{ Denotes changes to ADD. 98 - 10/15/76 CO ADD. 98 - 5/5/77

H-1 VIADUCT (WB)

INDEX TO DRAWINGS
ESTIMATED QUANTITIES

KEEHI INTERCHANGE
F.A.I. PROJ. NO. I-HI-1 (130): 17

PLANS ~ COLUMN HINGE DOWEL ARRANGEMENTS
Scale: 1/2" = 1'-0"

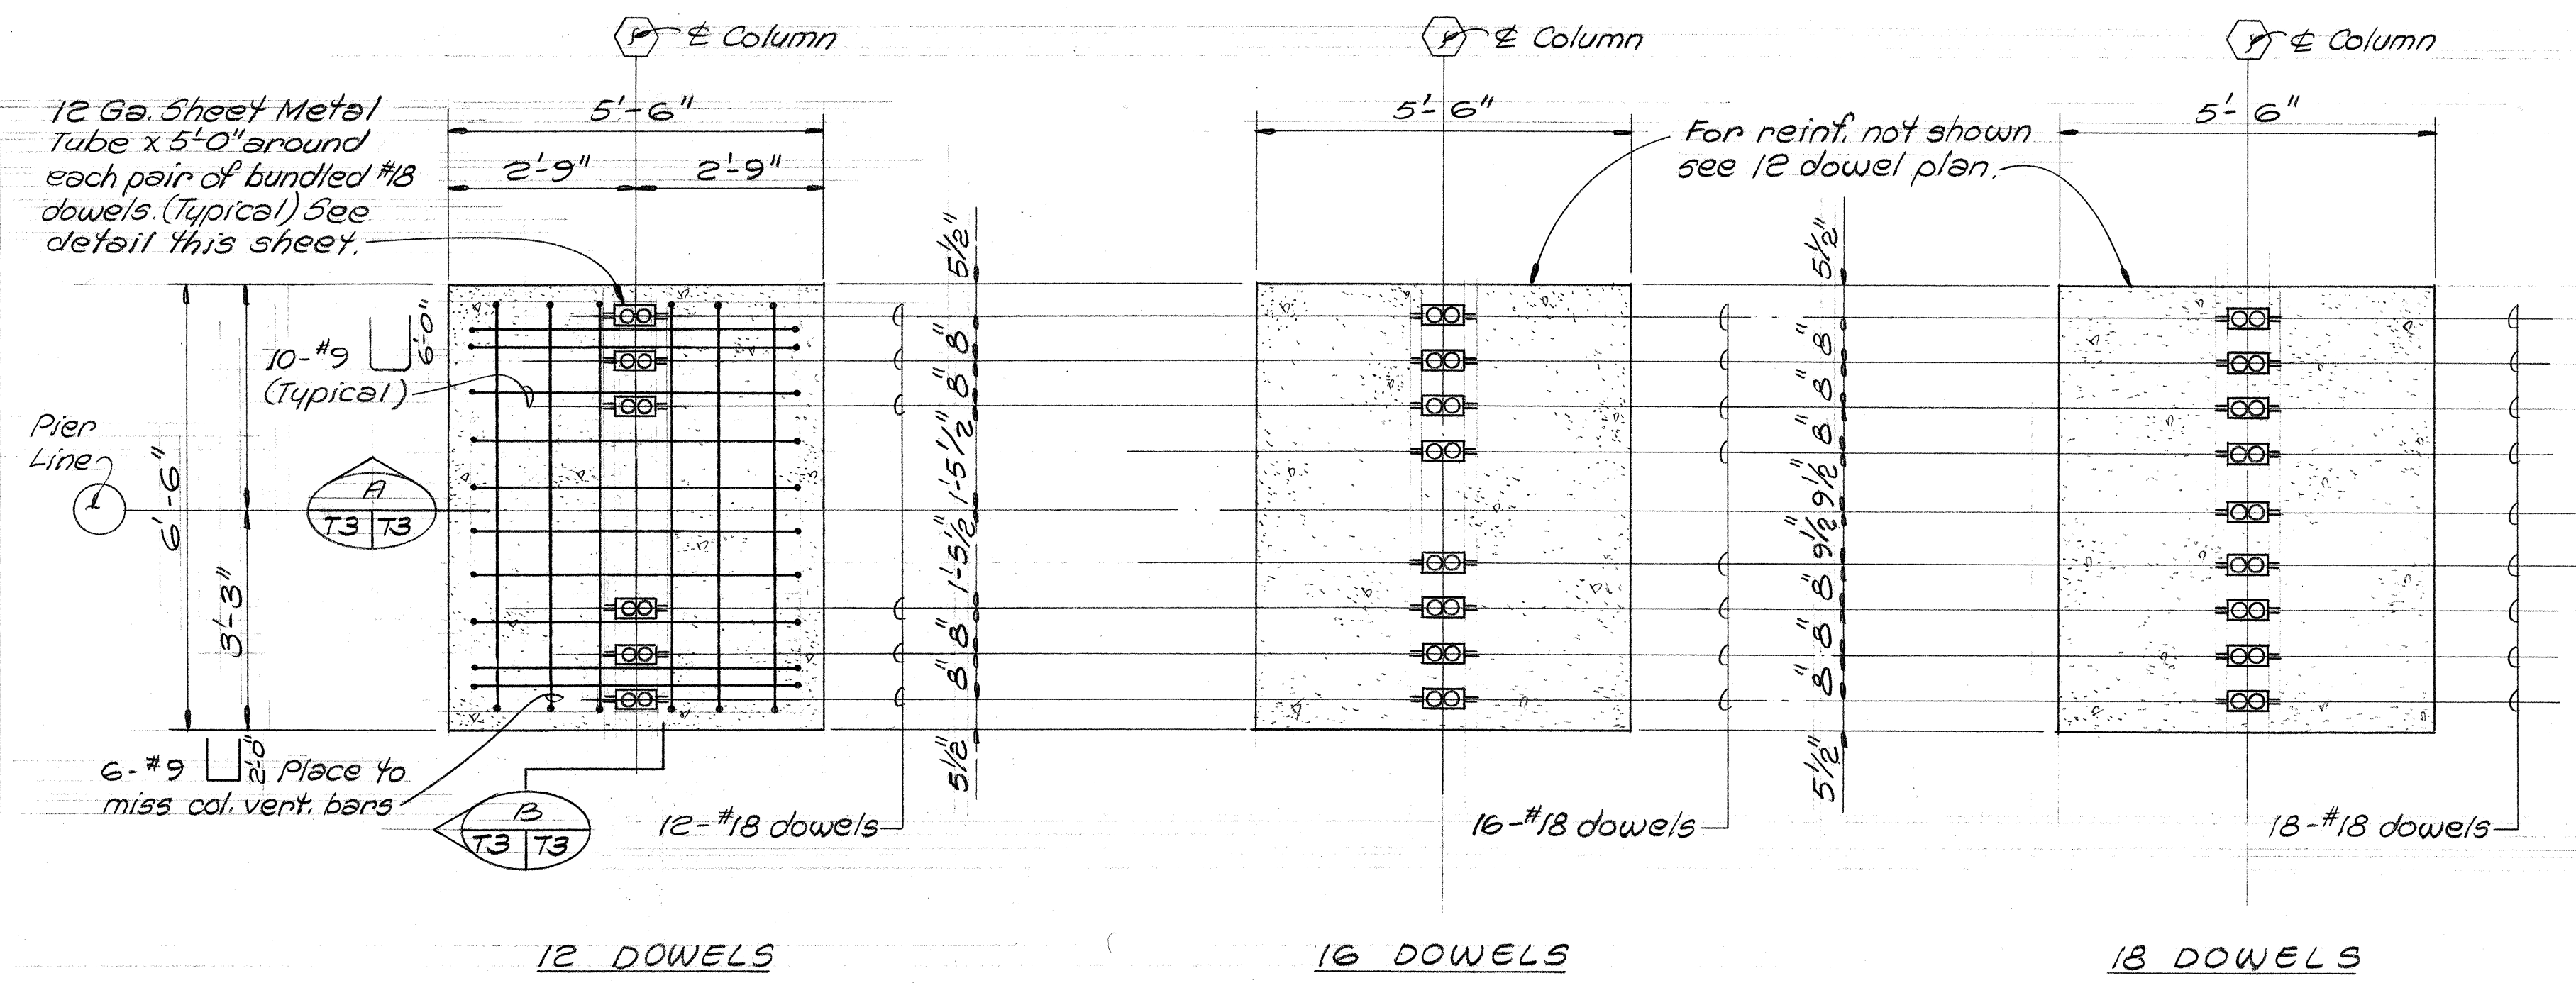
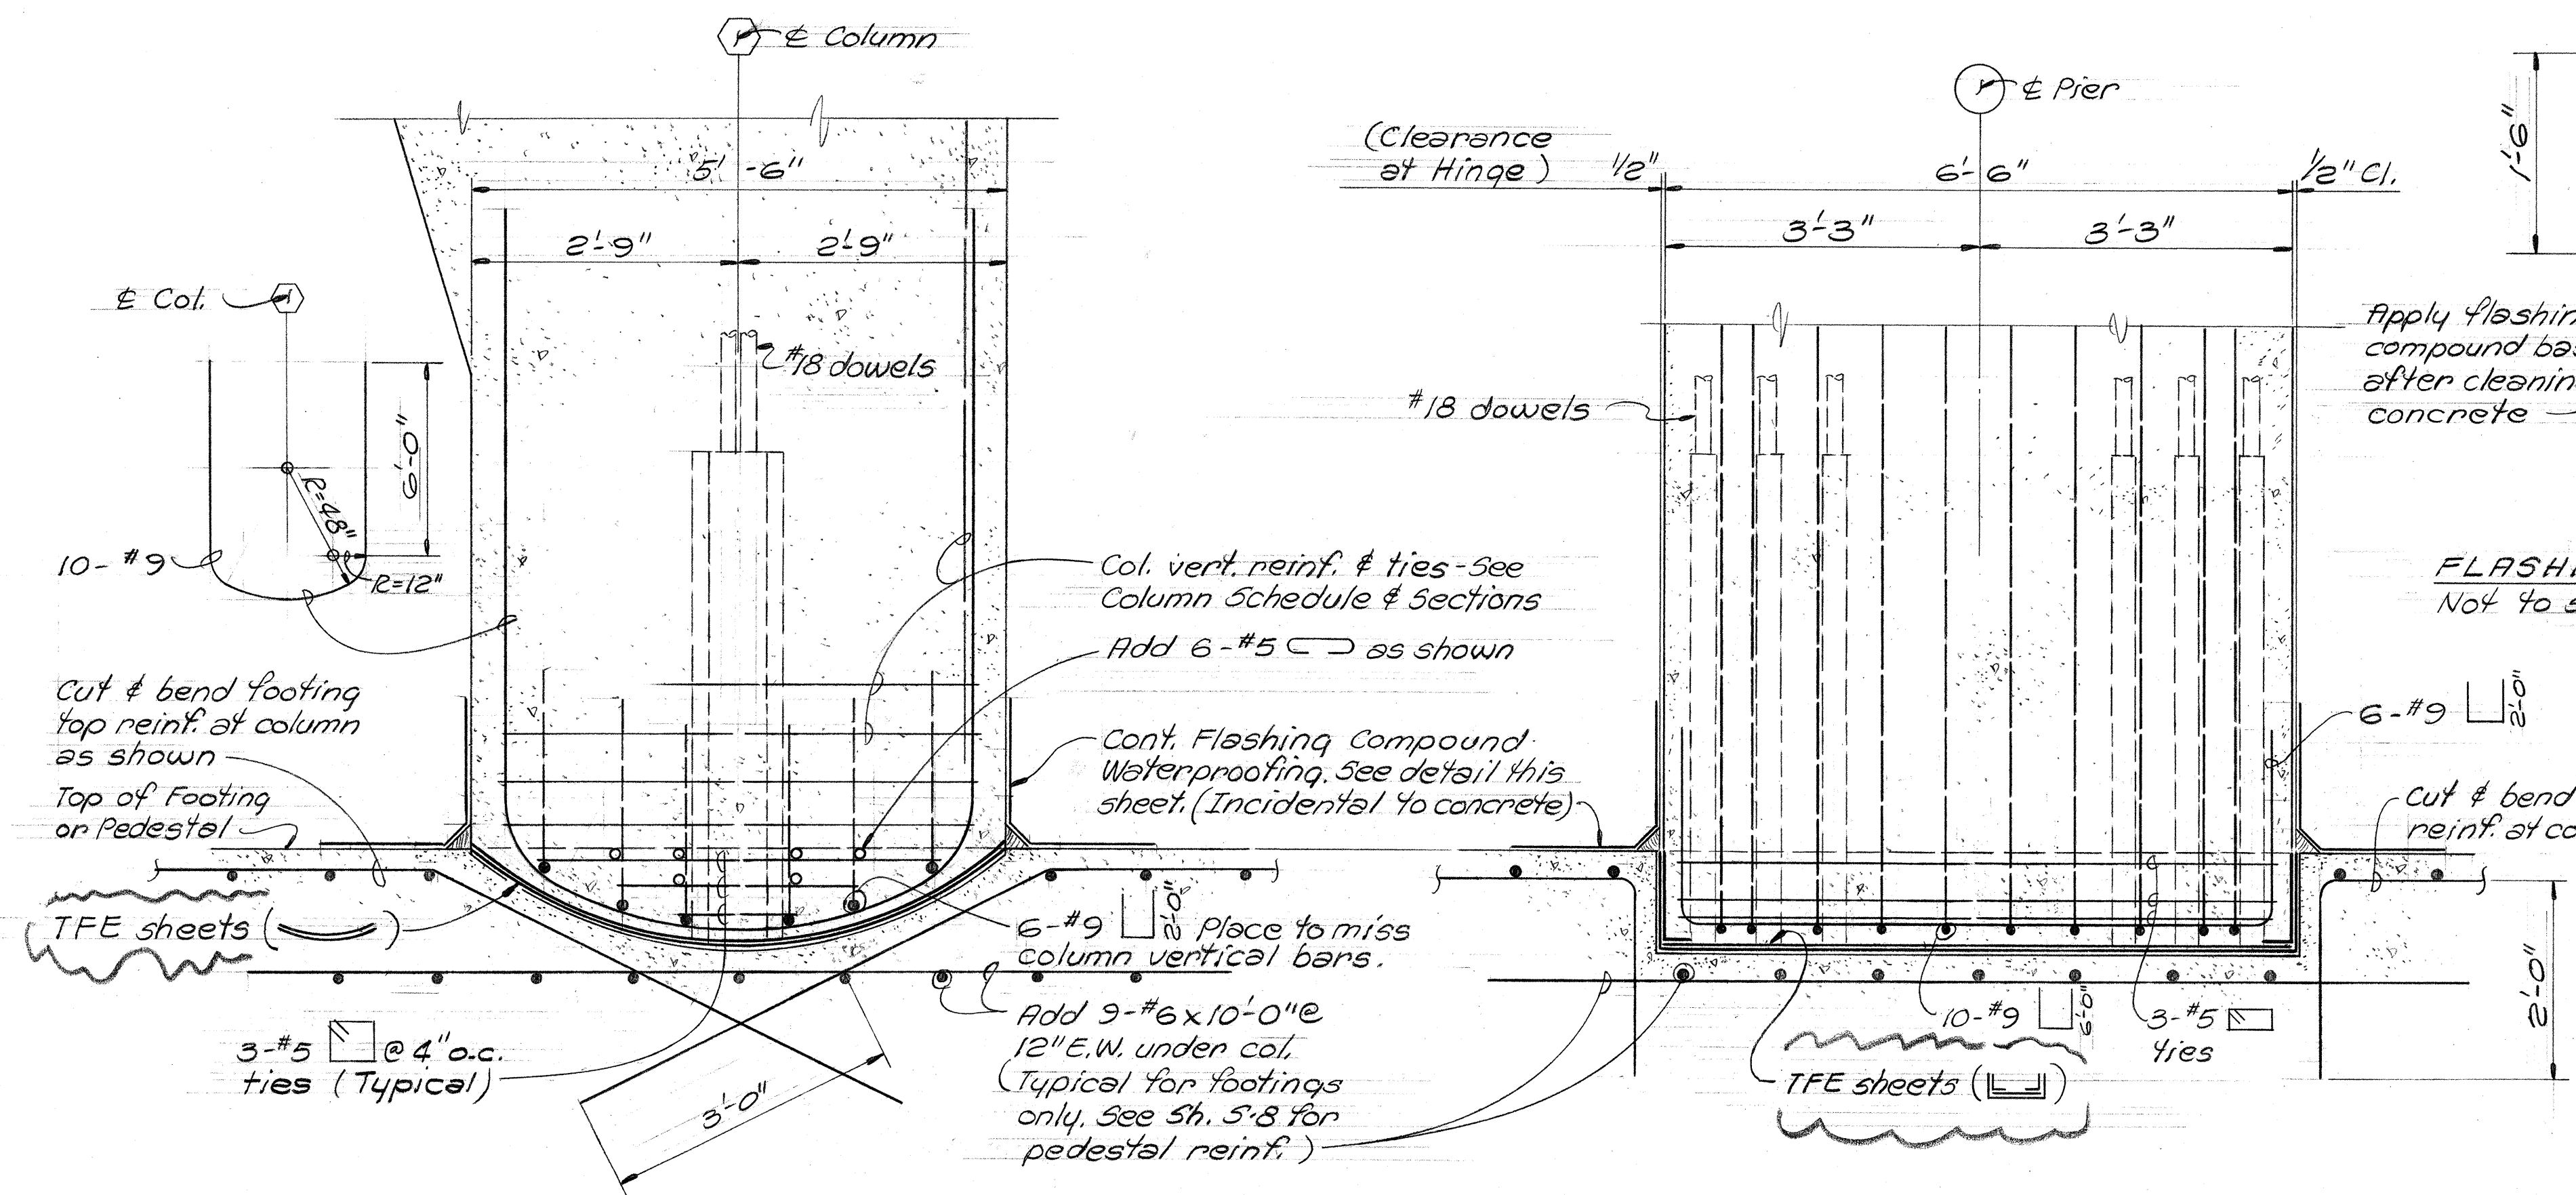
10/15/76	Revise Hinge Assembly details
DATE	REVISION
STATE OF HAWAII DEPARTMENT OF TRANSPORTATION HIGHWAYS DIVISION	
TYPICAL DETAILS COLUMN HINGE REINFORCING DETAILS	
KEEHI INTERCHANGE F.A.I. PROJ. No. I-HI-1 (130):17	
Scale: As Shown	Date: Aug. 16, 1976
SHEET No. T3 OF 20 SHEETS
